RE: DENYING AN APPEAL (AP23- 002) AND AFFIRMING THE PLANNING COMMISSION'S APRIL 11, 2023 ACTION APPROVING AN ENVIRONMENTAL AND DESIGN REVIEW PERMIT (ED22-016) FOR A NEW MIXED-USE BUILDING WITH 162 RESIDENTIAL UNITS AND 8,900 SQUARE FEET OF GROUND FLOOR COMMERCIAL SPACE LOCATED AT 1515 4TH STREET AND DETERMINING THE PROJECT EXEMPT FROM THE CALIFORNIA ENVIRONMENTAL QUALITY ACT PURSUANT TO CEQA GUIDELINES SECTION 15332

1515 FOURTH STREET ASSOCIATES, LLC (the Applicant) is writing in response to the Appeal (AP23- 002) filed by Vikram Seshadri regarding the April 11th Planning Commission approval of the 1515 4th Street Project (the Project). The appeal fails to raise any significant, quantifiable, direct, and unavoidable impacts of the project, based on objective, identified written public health or safety standards, policies, or conditions as they existed on the date the application was deemed complete as required by the Housing Accountability Act (Government Code Section 65589.5). Accordingly, the Appeal has no merit and the Applicant requests that the City Council deny the Appeal.

**1515 4th Street - AMG Traffic Appeal Letter
Of Response**

1515 4th Street - AMG Traffic Peer Review

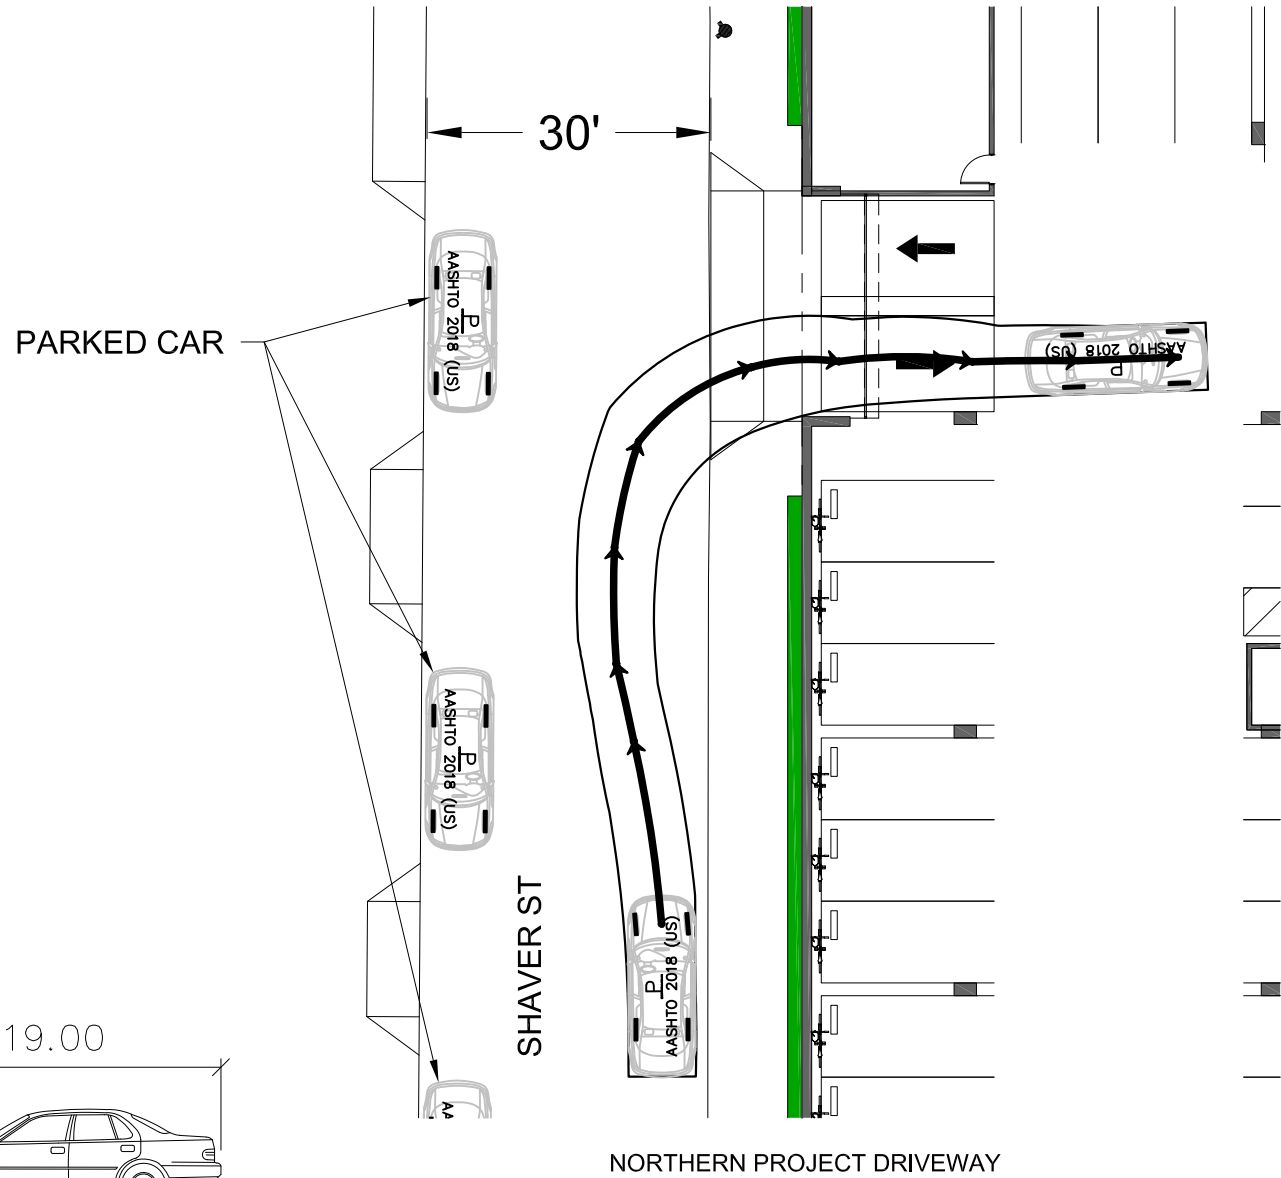
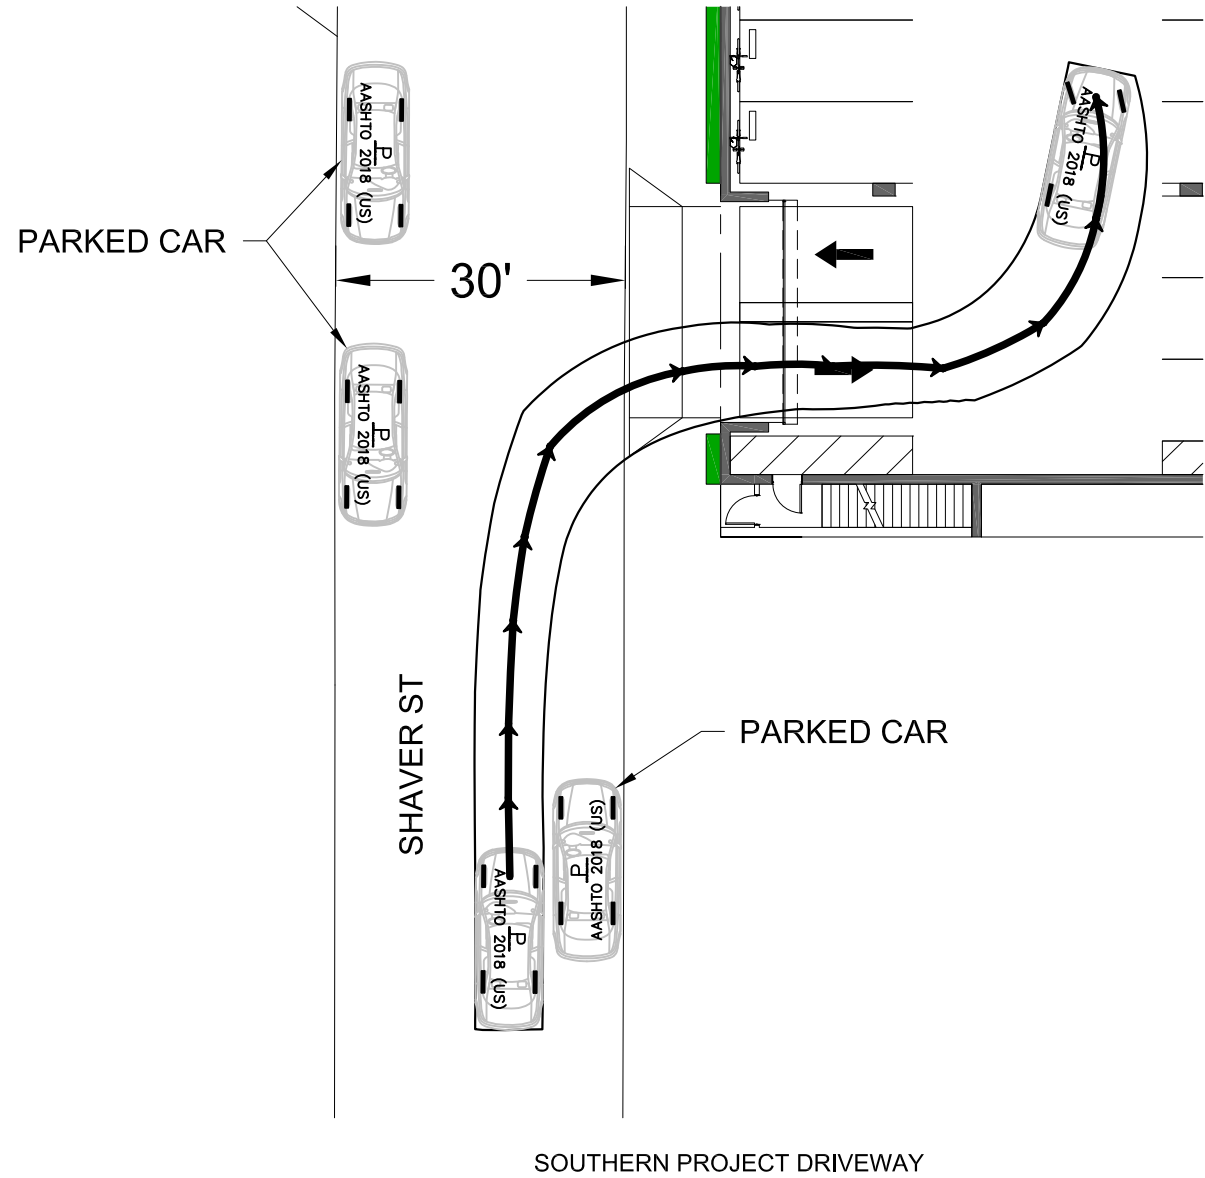
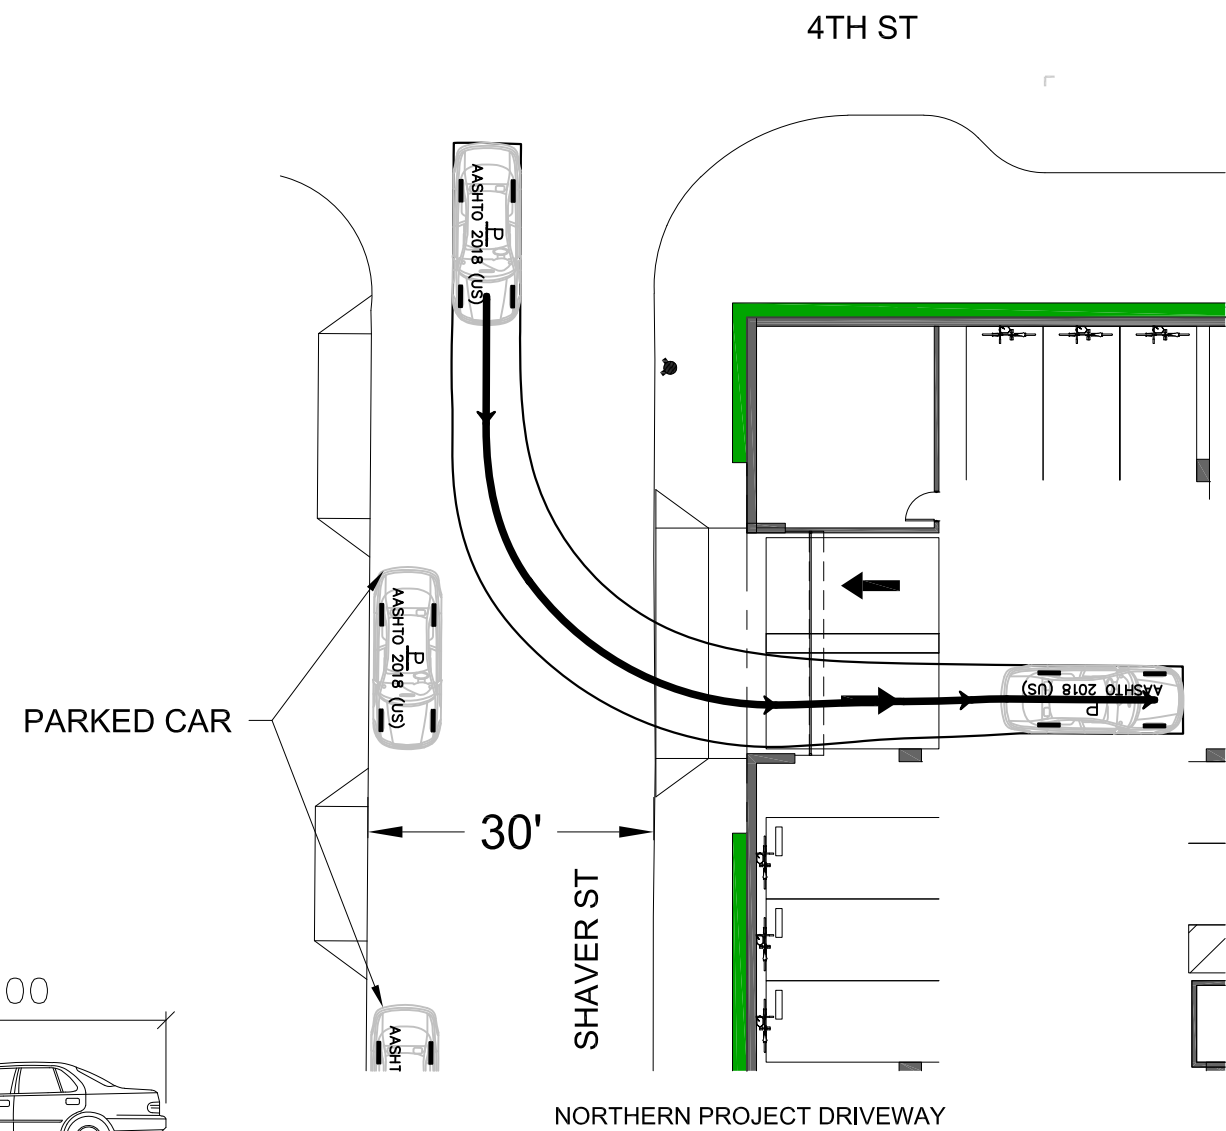
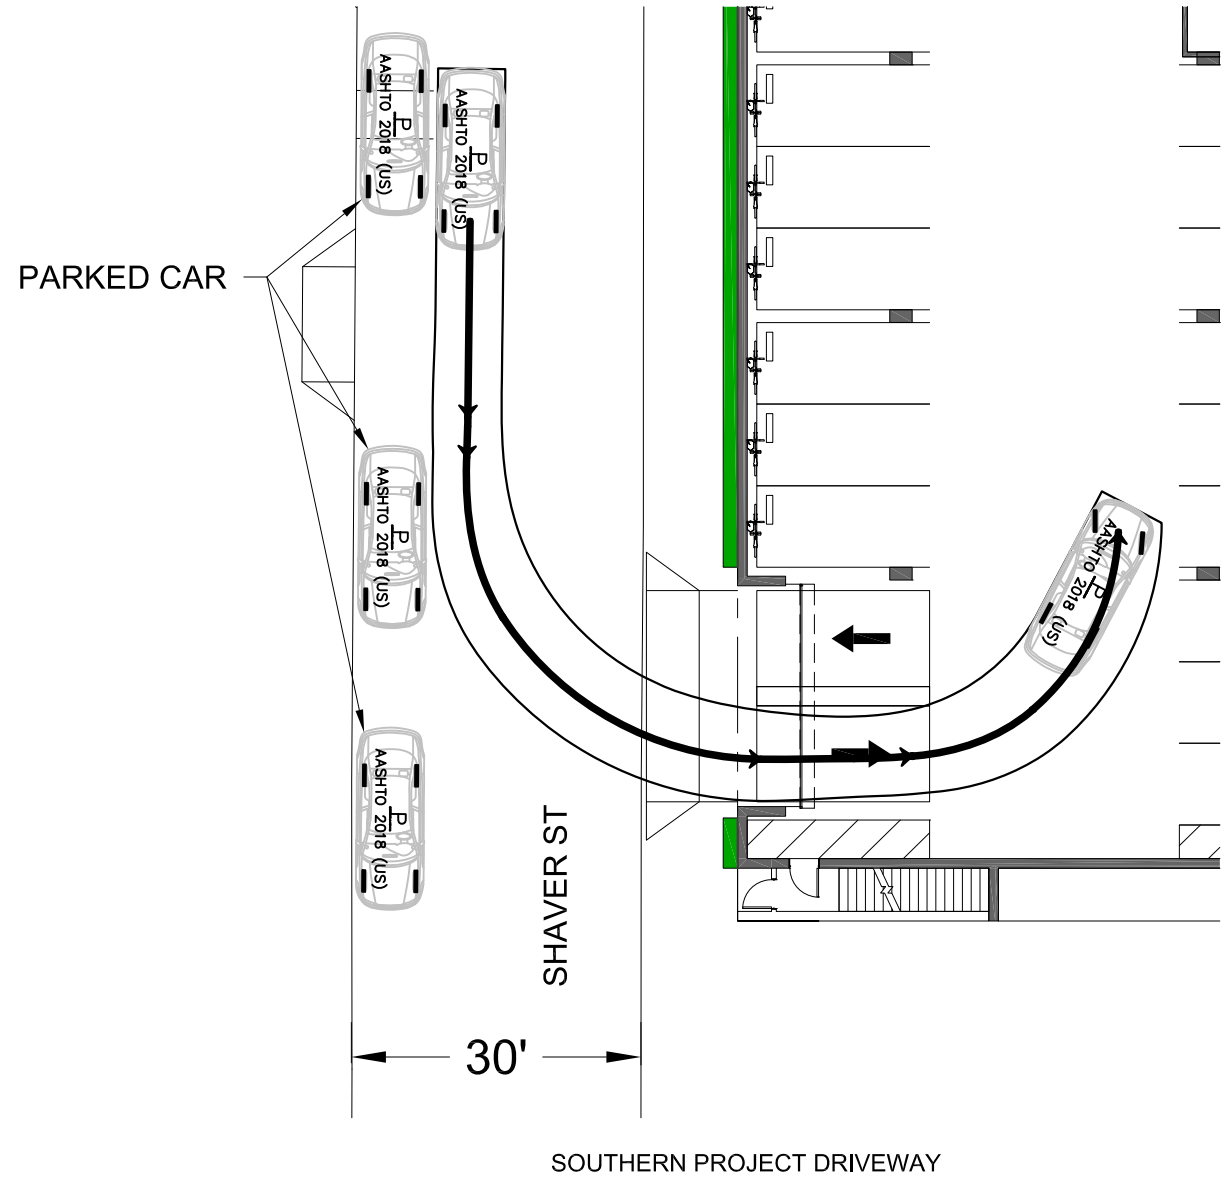
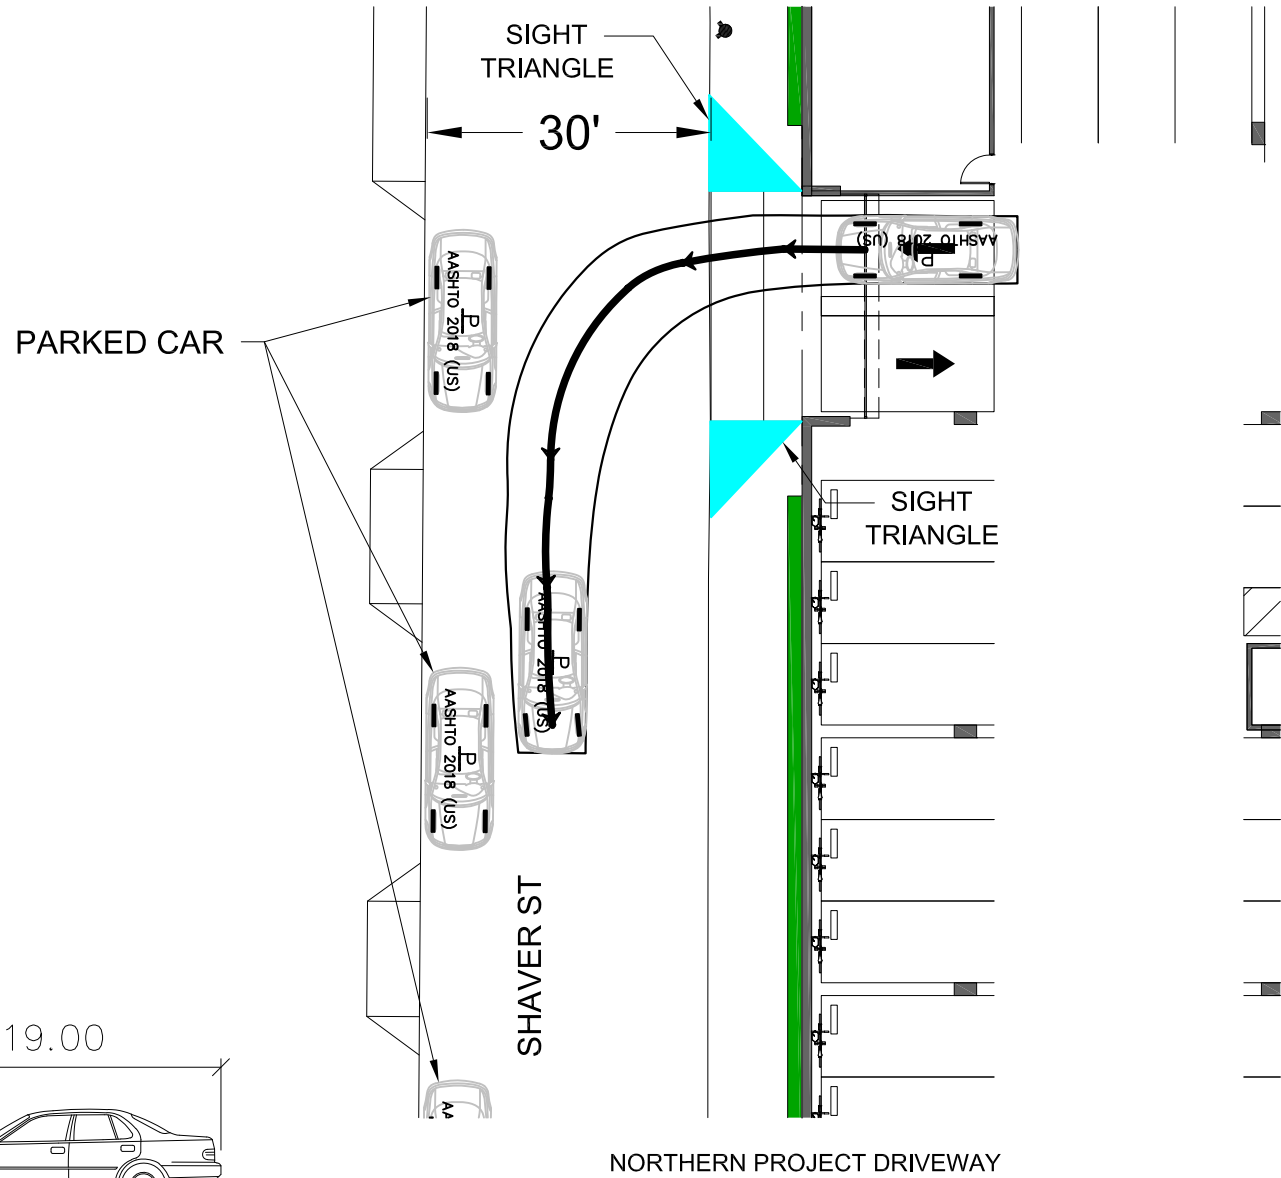
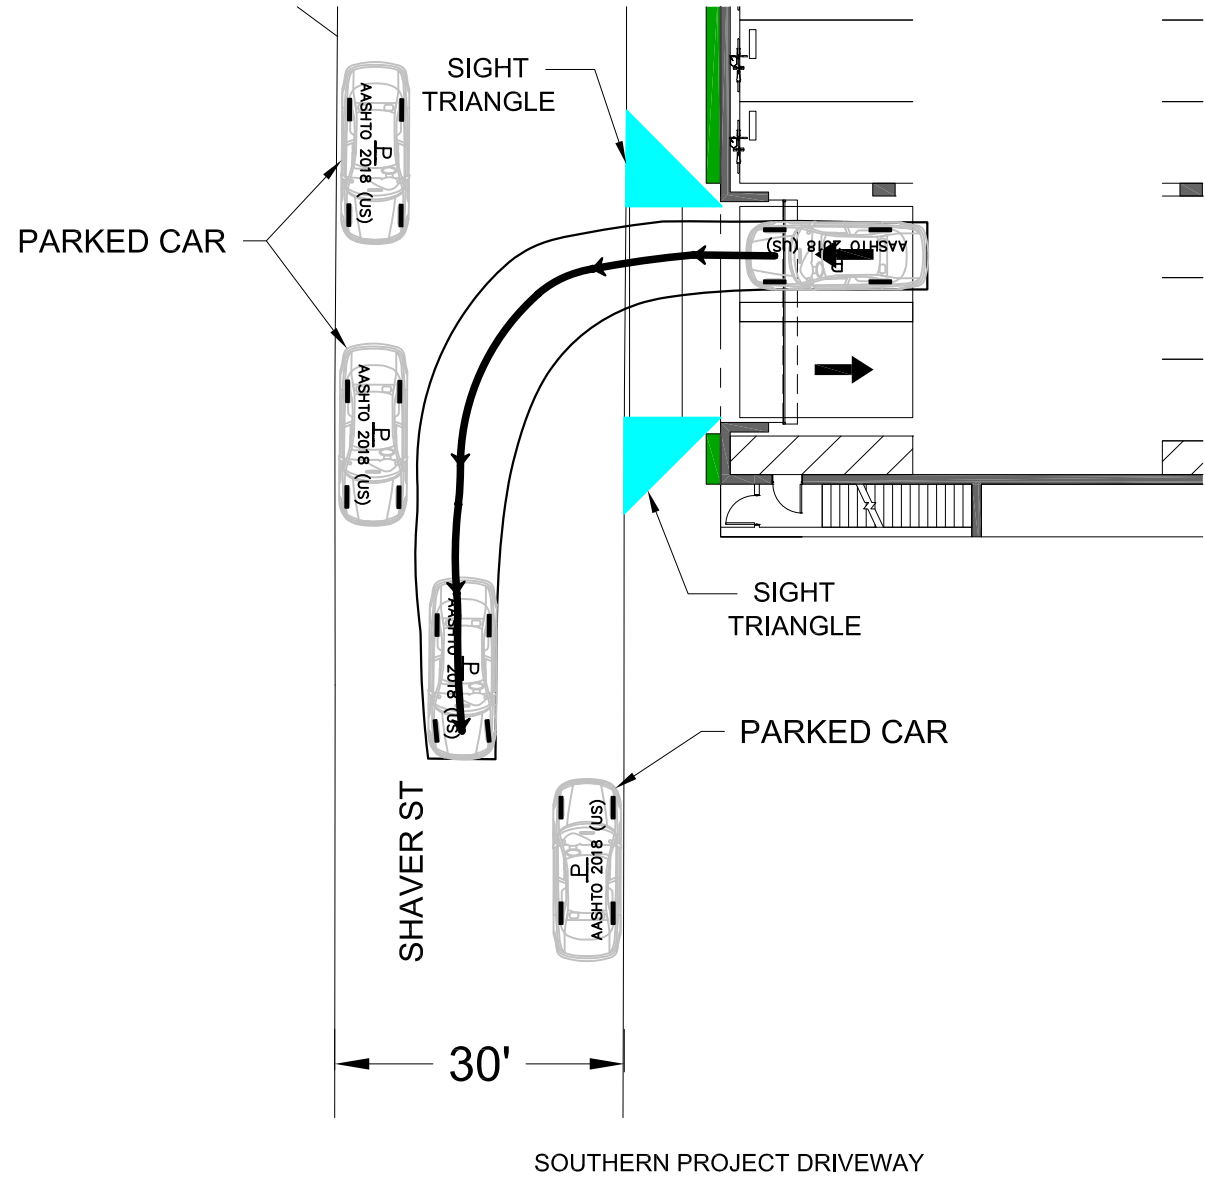
AMG properly analyzed internal circulation within the parking garage. No vehicles larger than a single unit car will be allowed in the parking garage. As indicated in the LTA report, entrance and exit of vehicles will be adequate. In addition to the report, AMG prepared turning radii diagrams to show that circulation and entrance within the parking garage is adequate. The diagrams are included as an appendix to this letter.

Sheet 1 shows the turning radius movements of a passenger vehicle entering the project driveways by making a left turn.

Sheet 2 shows the turning radius movements of a passenger vehicle entering the project driveways by making a right turn.

Sheet 3 shows the turning radius movements of a passenger vehicle exiting the project driveways by making a left turn. The driveway sight triangle is also depicted in this sheet per San Rafael Municipal Code Guidelines.

Sheet 4 shows the turning radius movements of a passenger vehicle exiting the project driveways by making a right turn. The driveway sight triangle is also depicted in this sheet per San Rafael Municipal Code Guidelines.
